CONTRACT NO. 1730

MONONGAHELA DEEP TUNNEL INTERCEPTOR CLEANING

ADDENDUM NO. 1

1. *Access shaft M-50A*
2. *Drop shaft M-52, Drop shaft M-53*

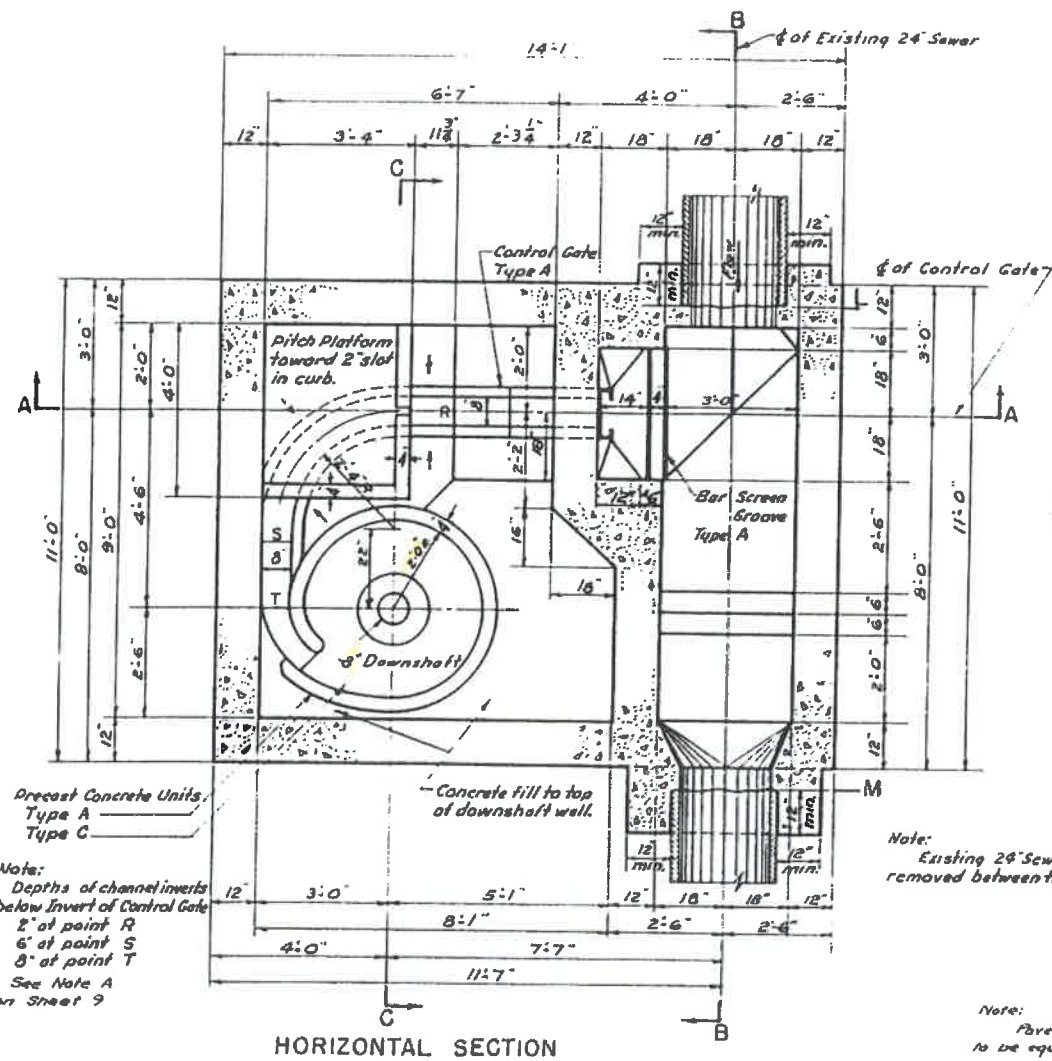
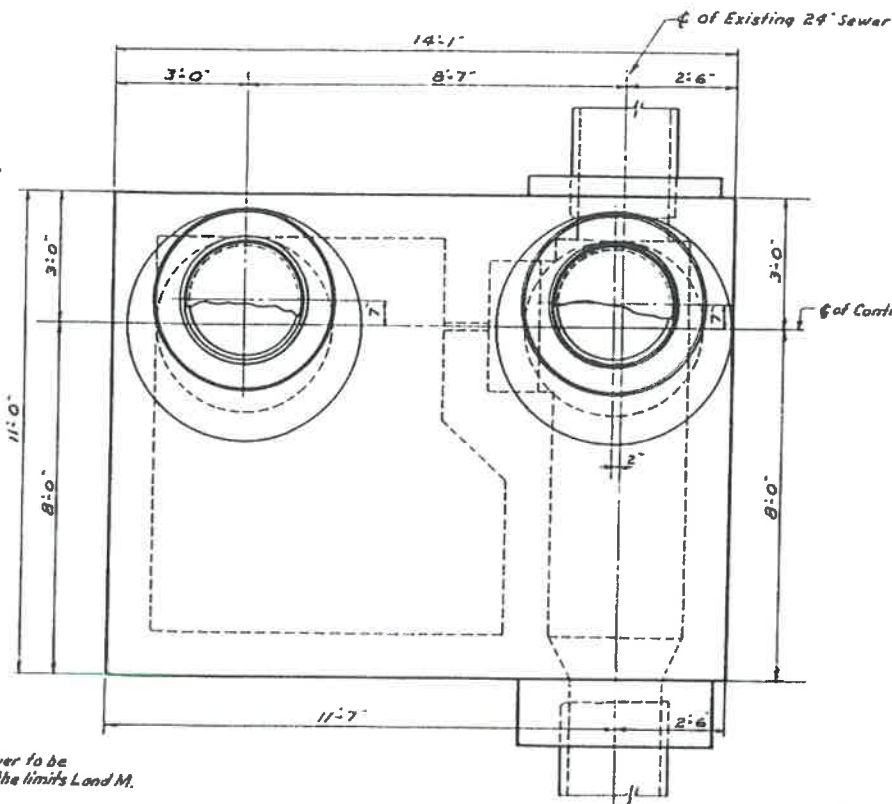
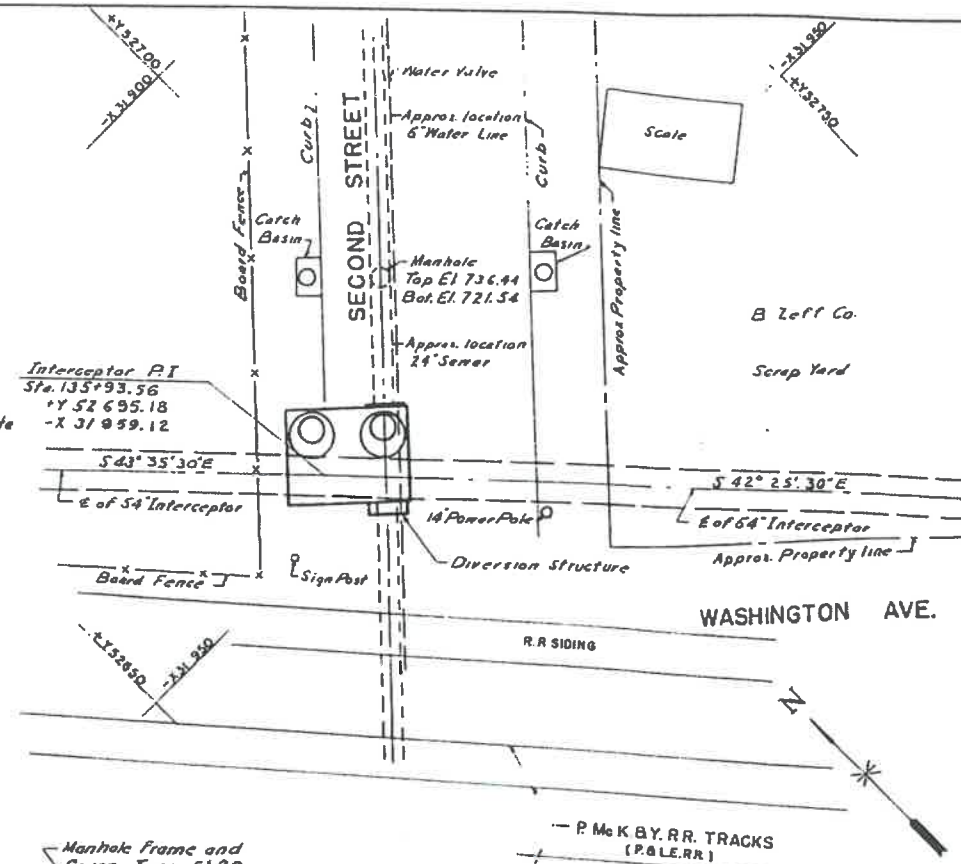
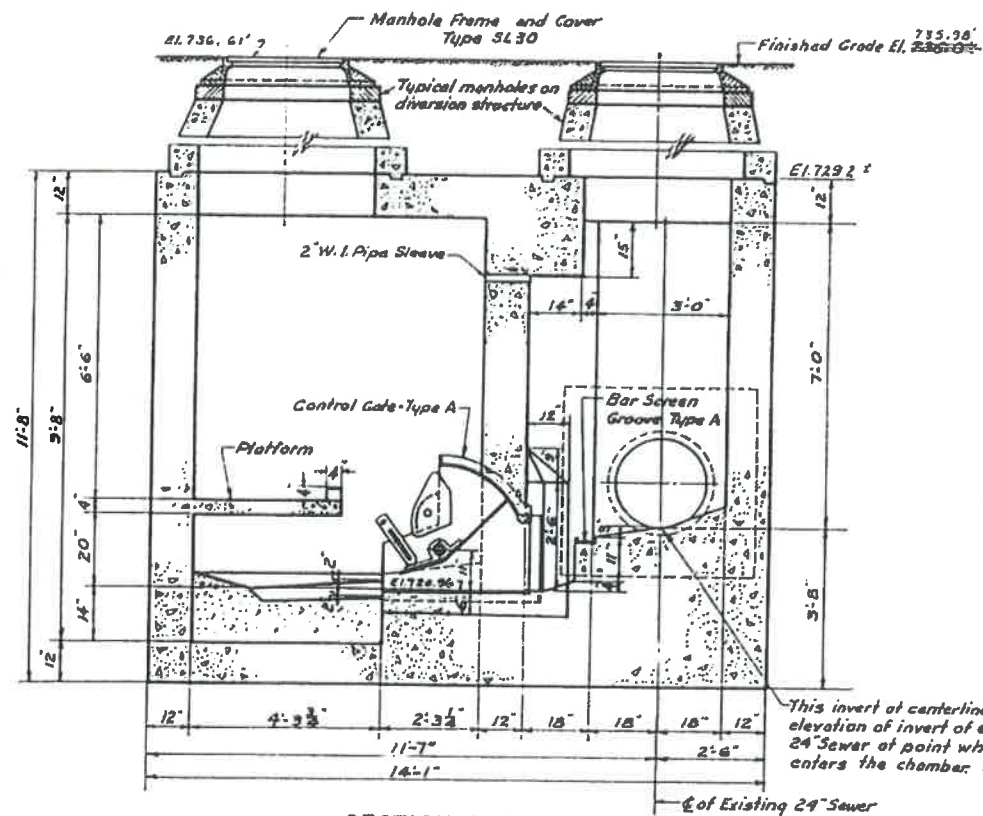
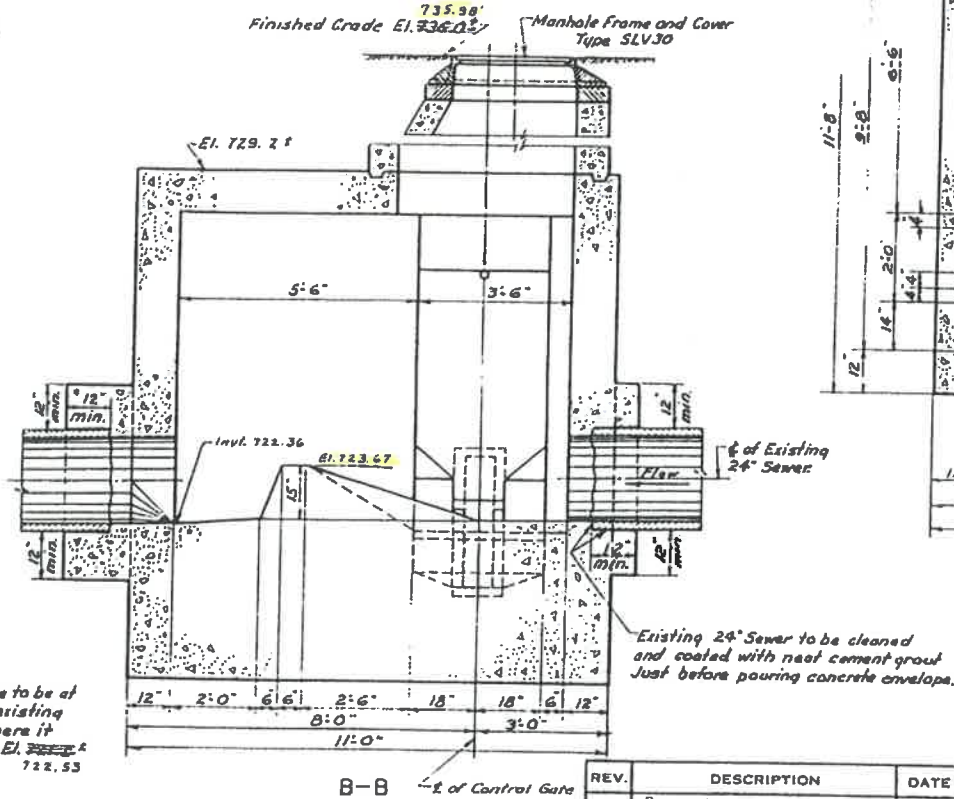
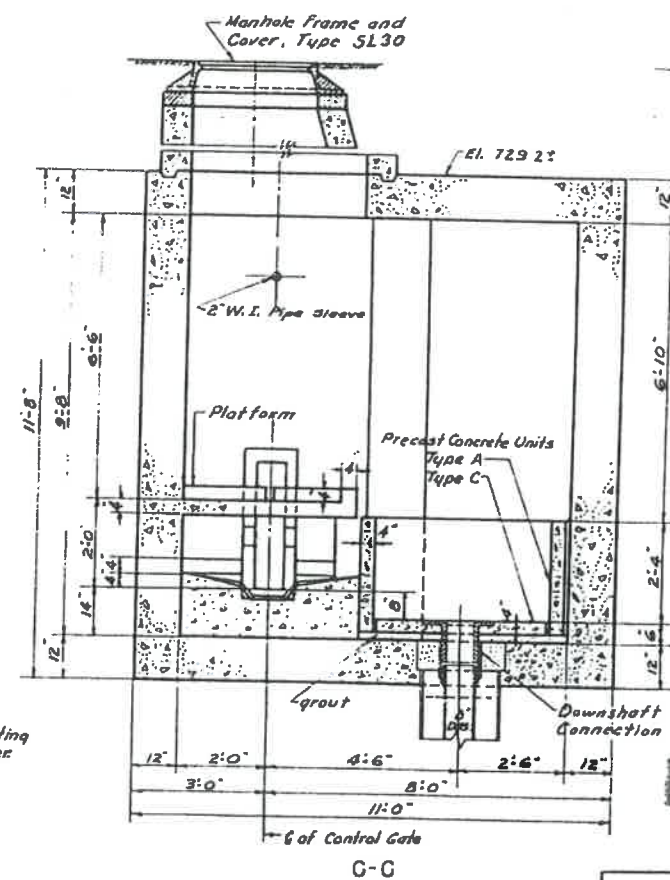
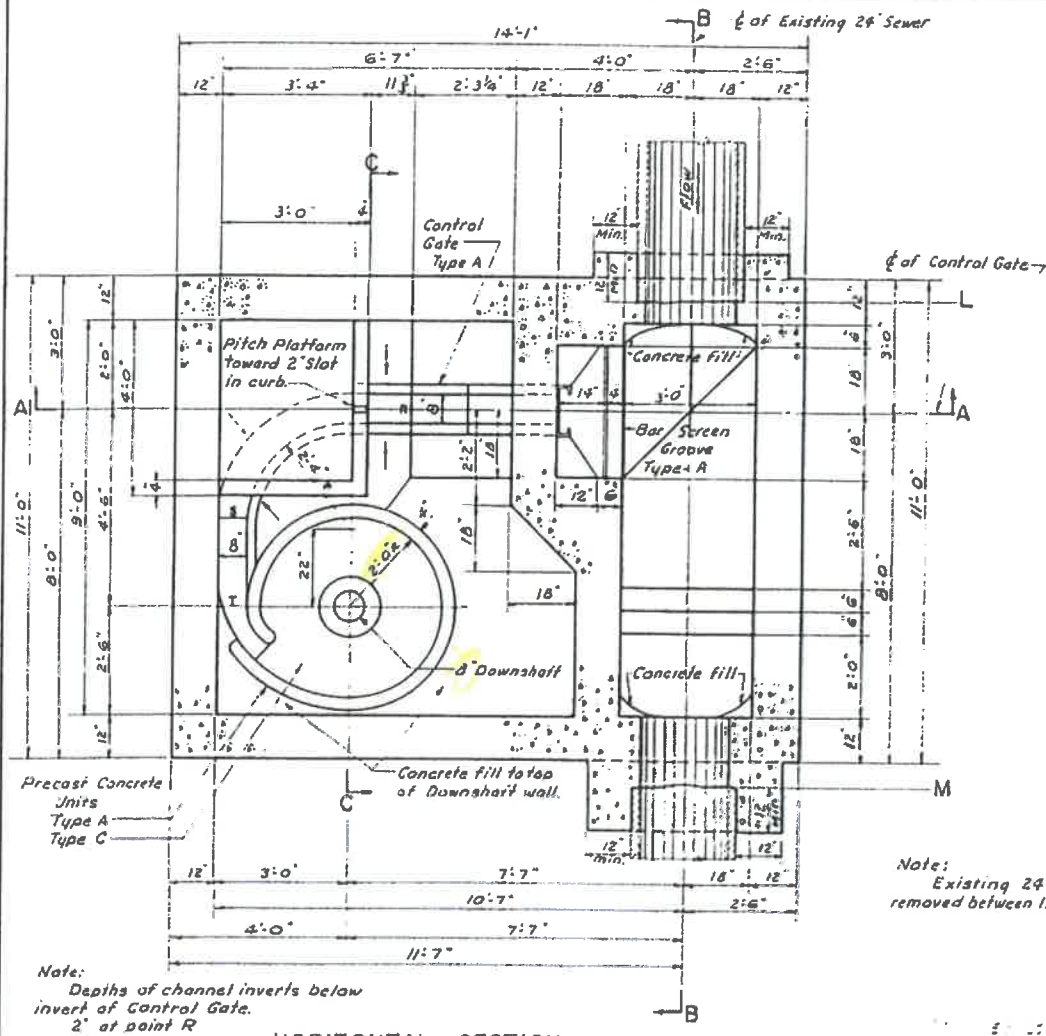
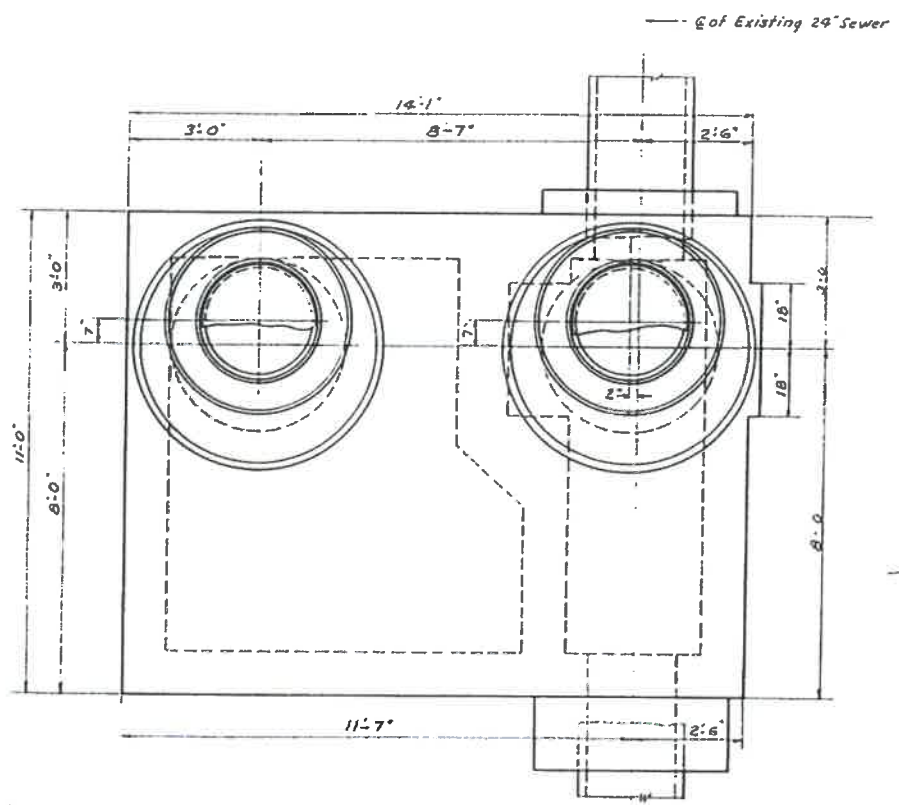
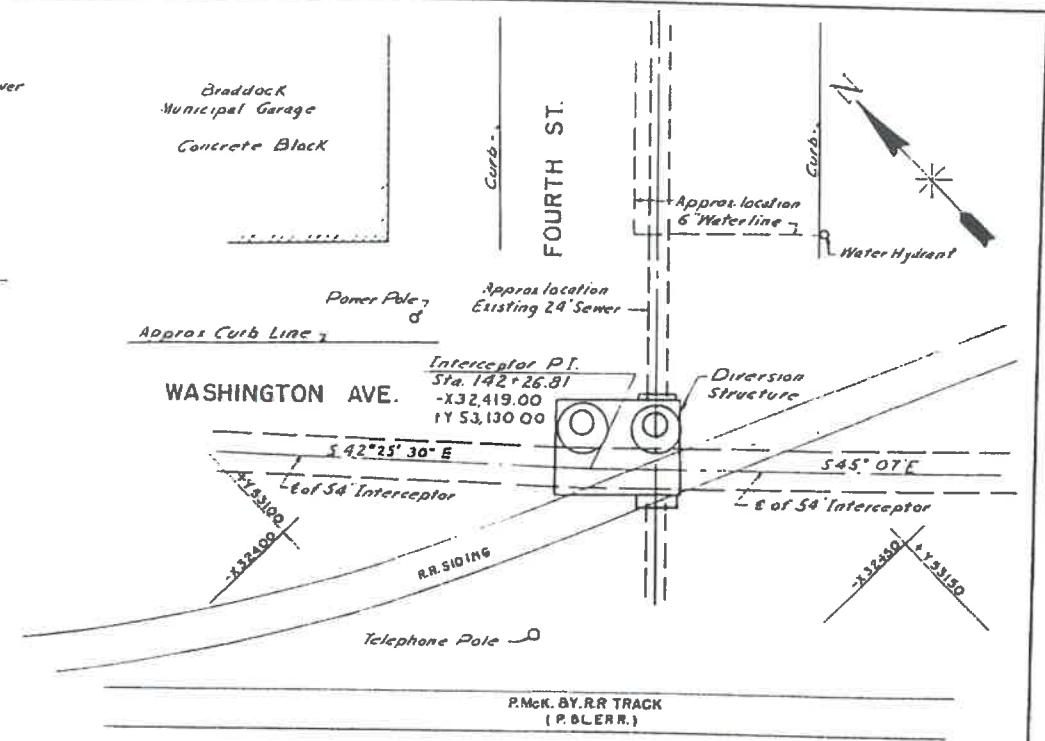
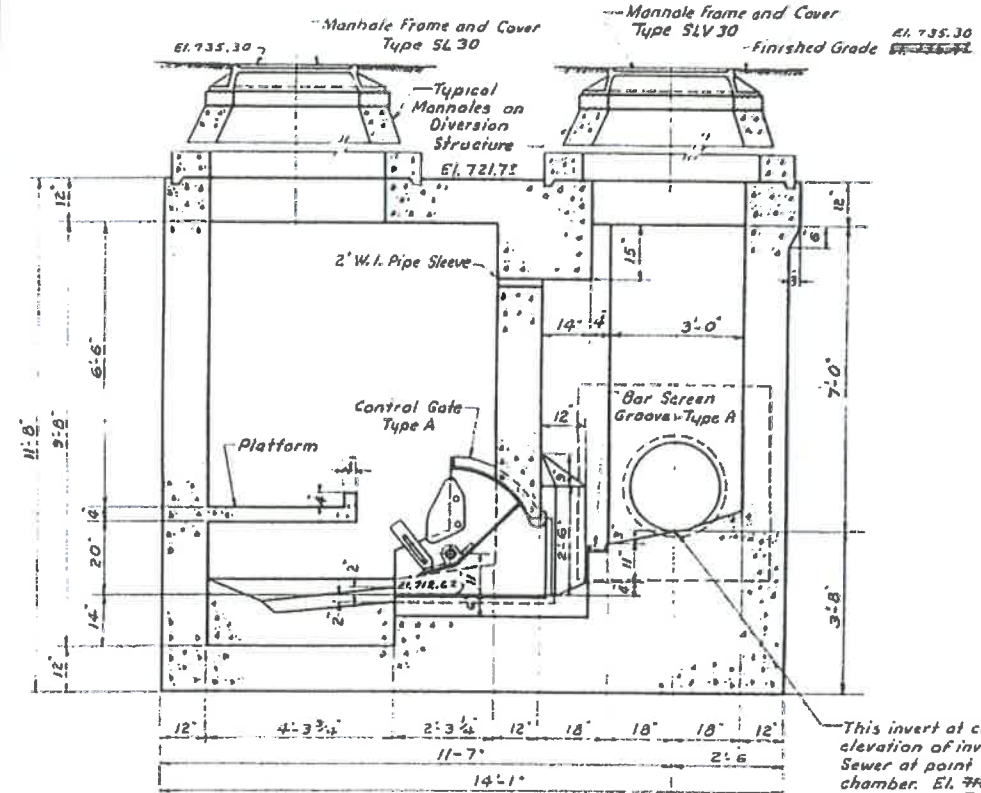
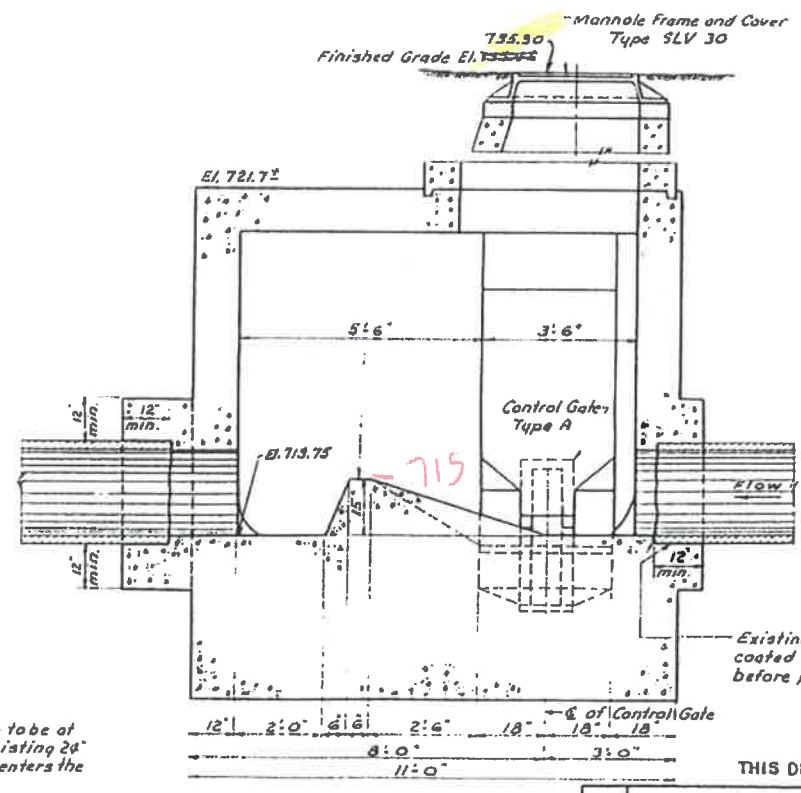
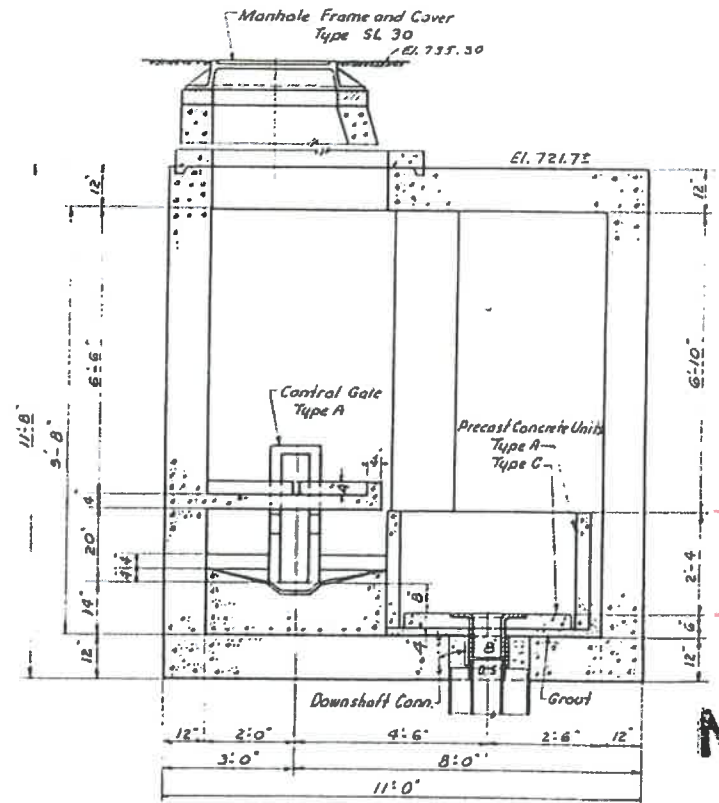
1. *Article 1, Paragraph 8, p. 1-4, shall change to “TOTAL BASE BID (Sum of Tasks 1, 2, 3a, 3b, plus Contingent Items C-4 & C-5)”*
2. *Article 2, Paragraph 1, p. 2-3, shall change the 2nd sentence of the first paragraph to “The M-53 drop shaft (8 inches) is located approximately 2,000 feet upstream of the M-50A access manhole.” The M-53 drop shaft was misidentified as a 12 inch diameter, it is actually 8 inch diameter.*
